## **NOTICE TO CONTRACTORS BIDDING THIS PROJECT**

Project Title: Building and Site Improvements at 6741 Downing Avenue, Bakersfield, CA

Contract No: 26016

### **ADDENDUM No. 2**

|     | <b>S4.2A</b> |

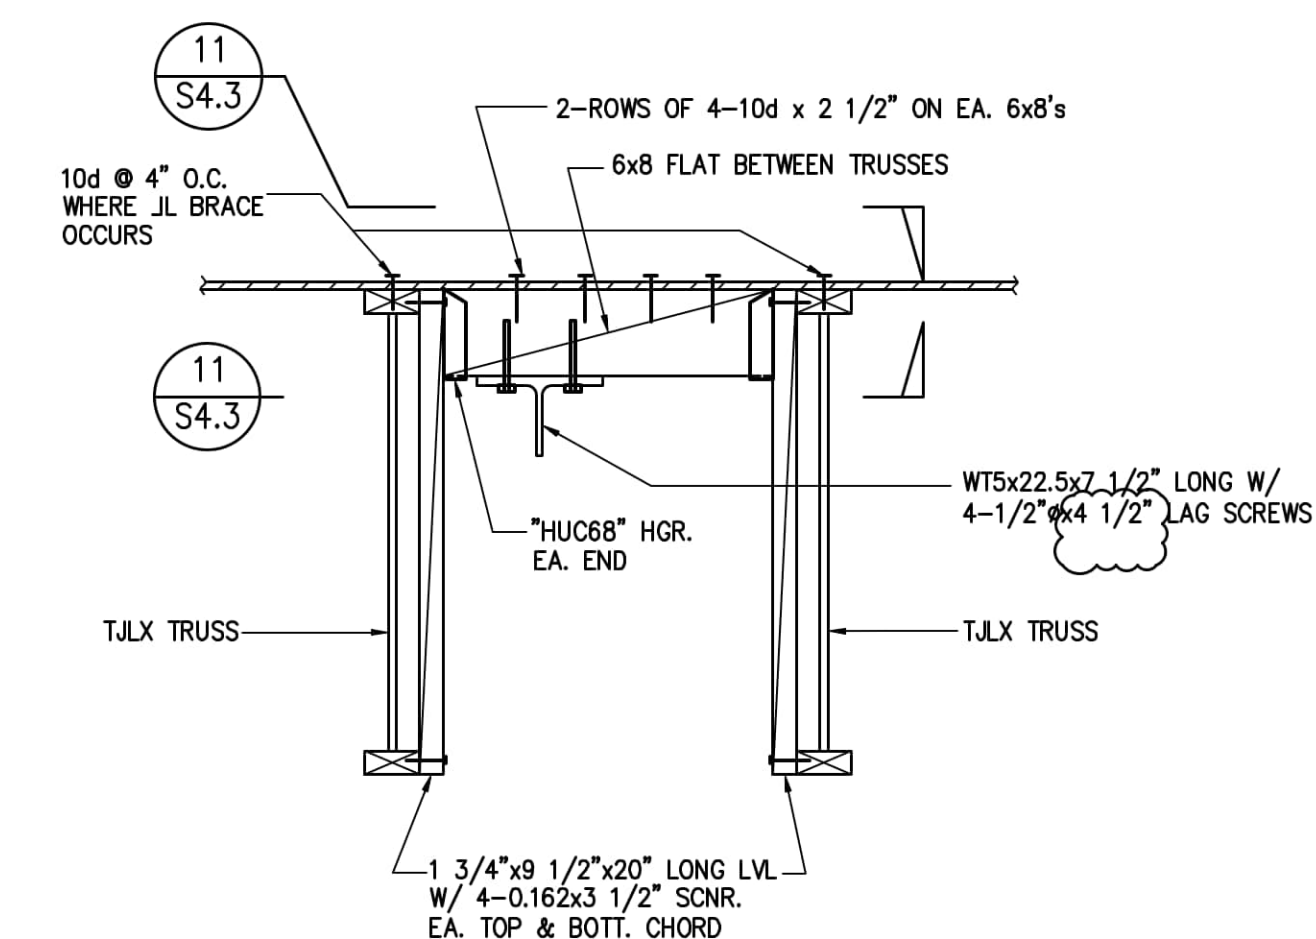
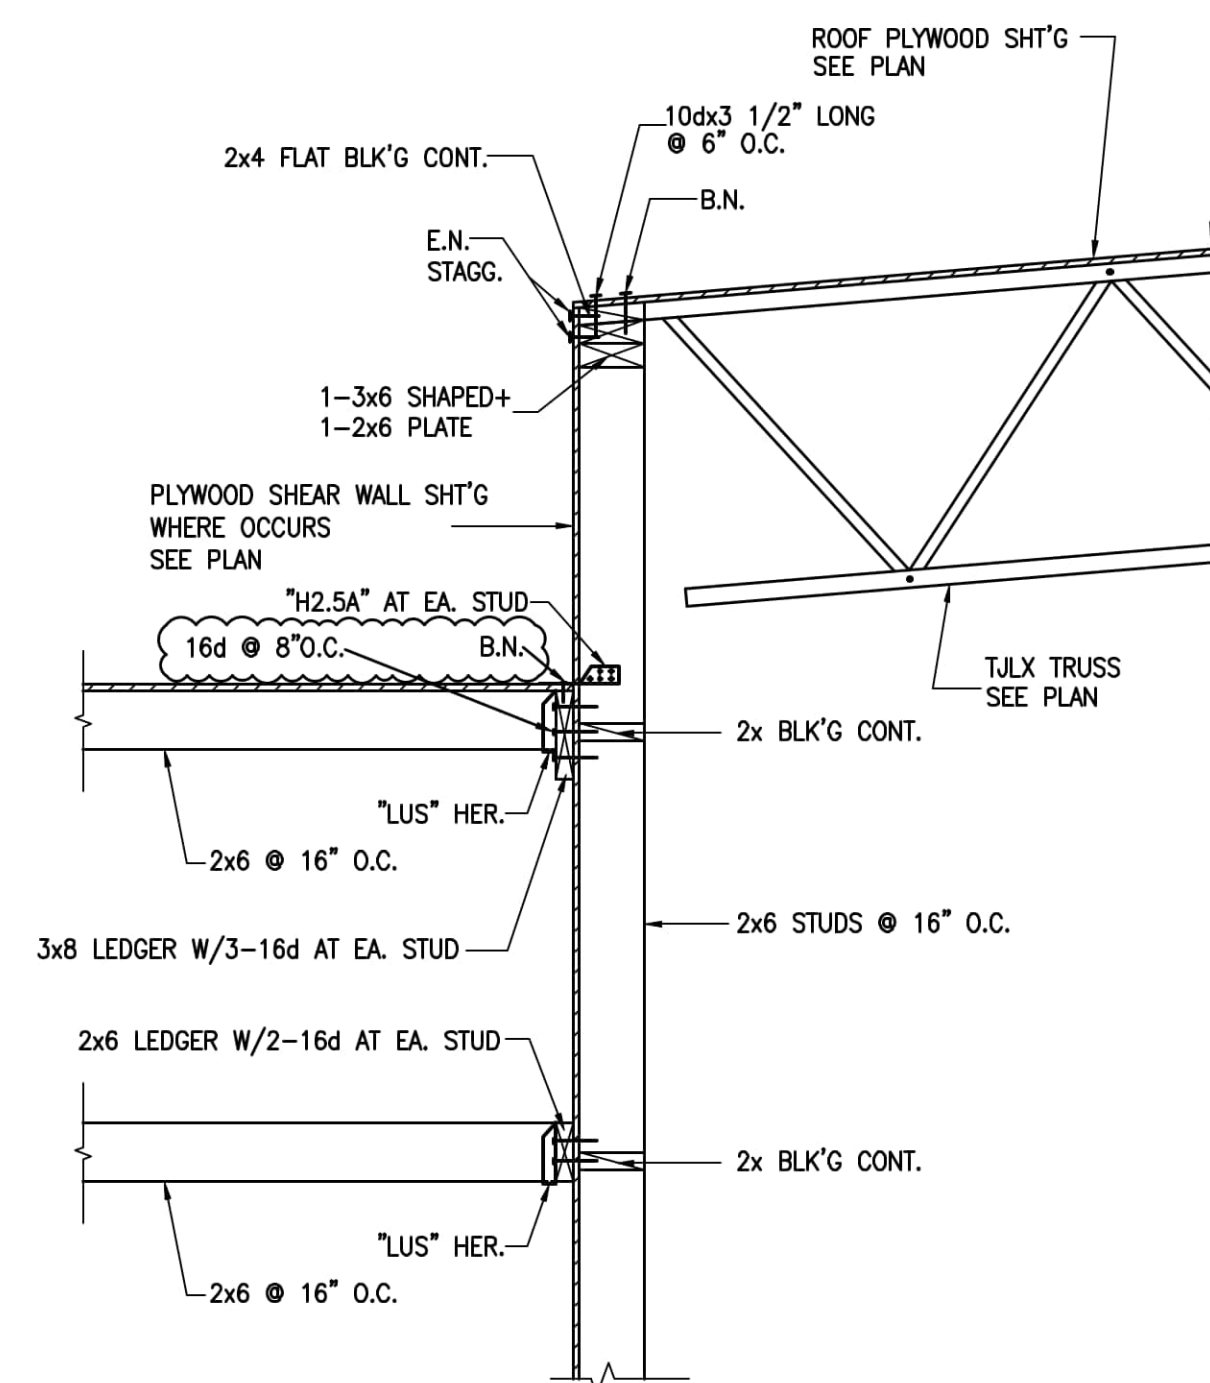
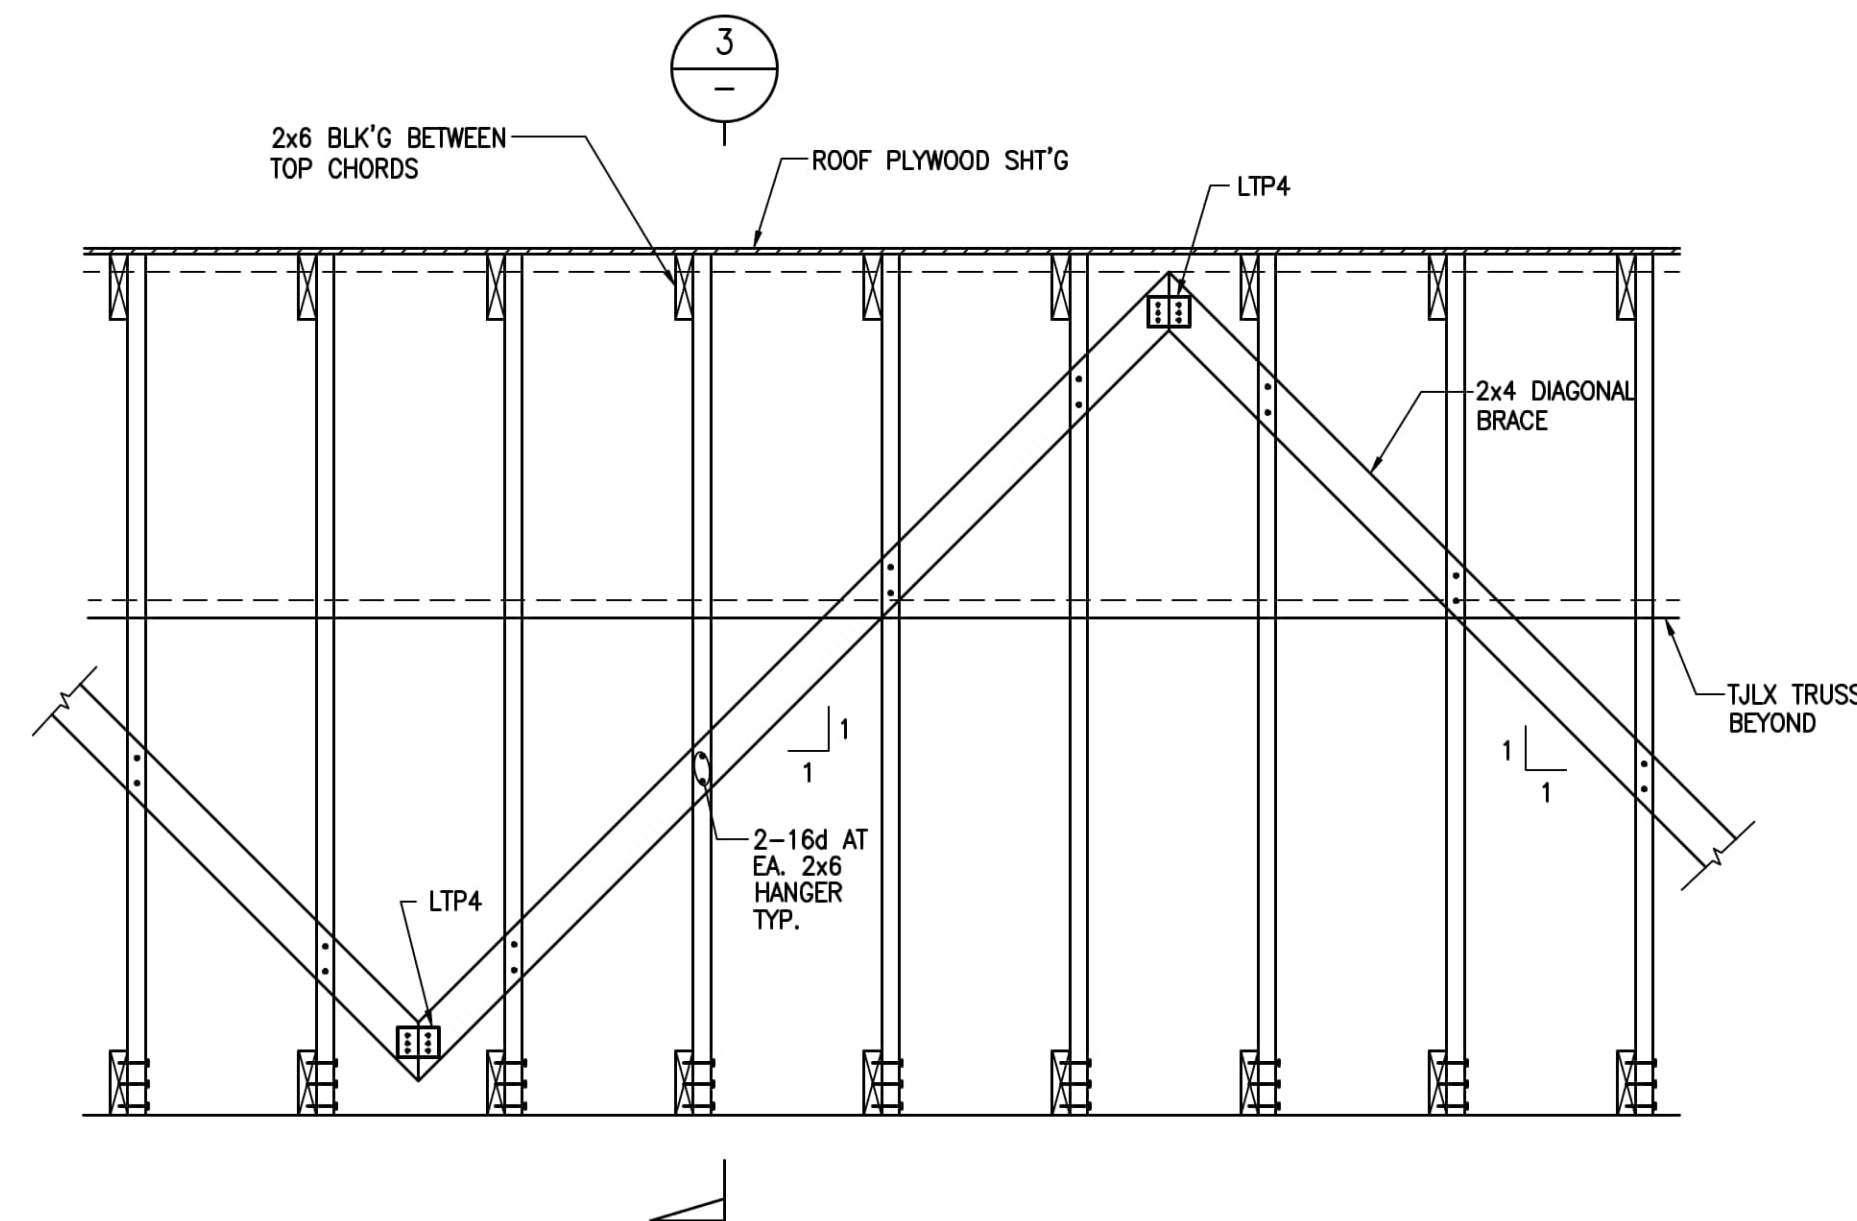
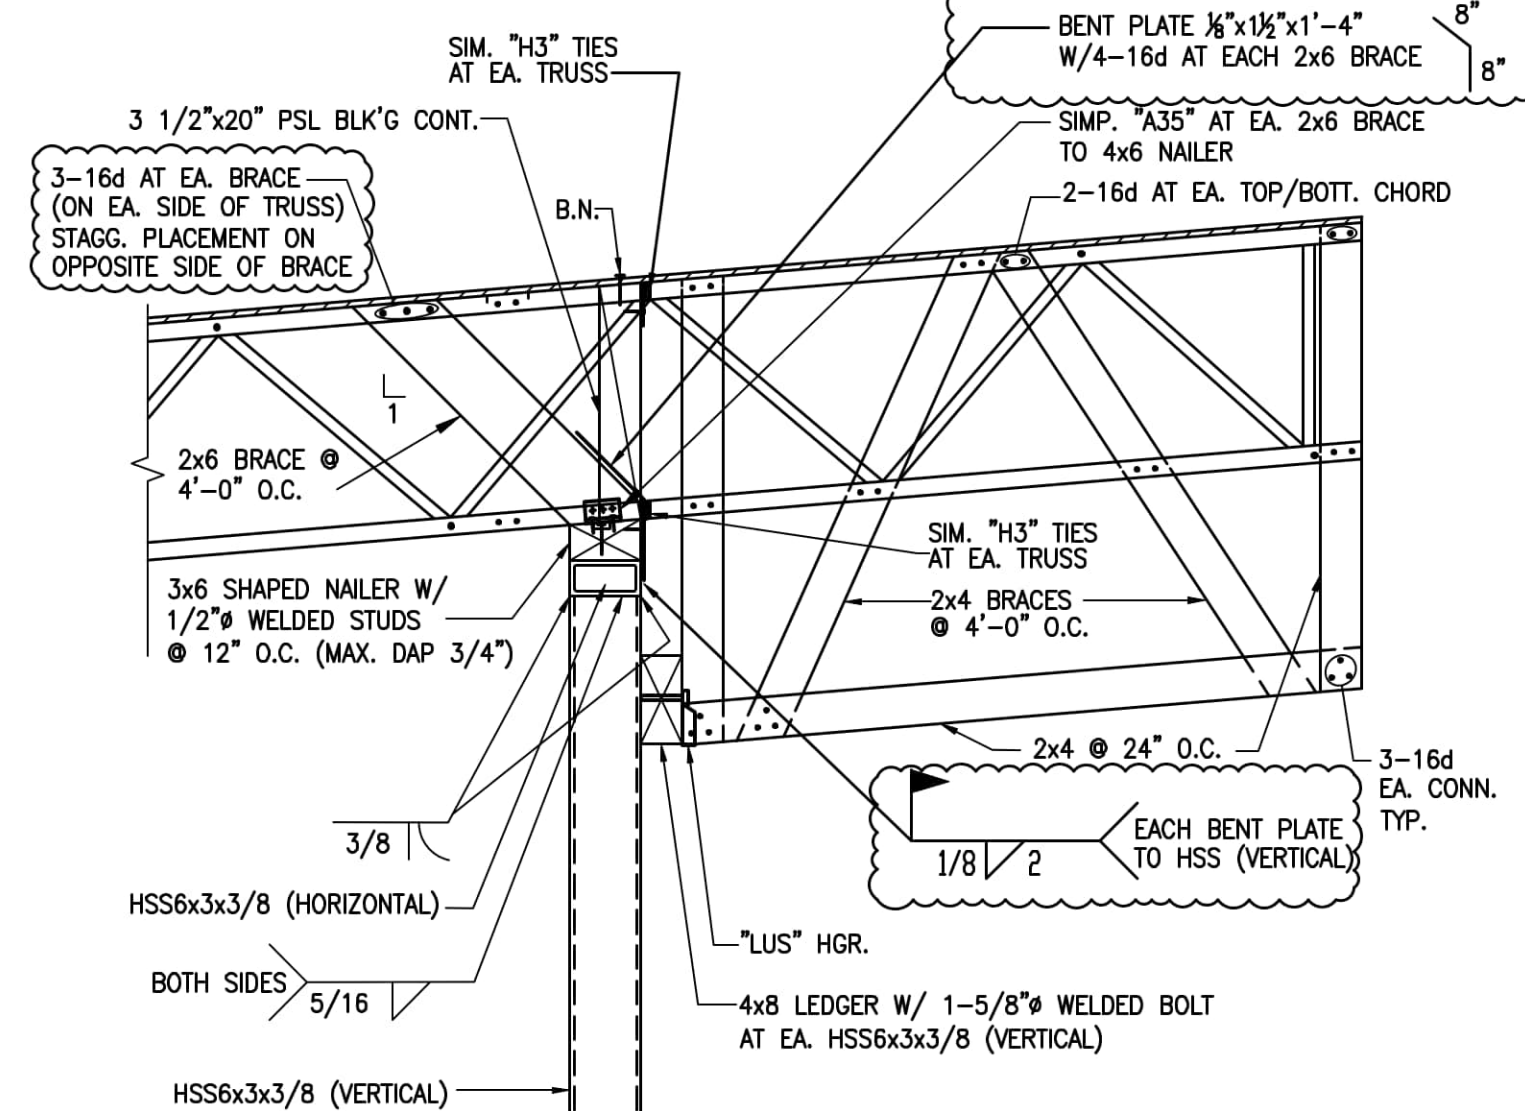
- j. Sheet S4.2 has been replaced with sheet S4.2A. Detail 3/S4.2 has been revised to reflect accurate condition. The revised sheet is attached to this addendum.
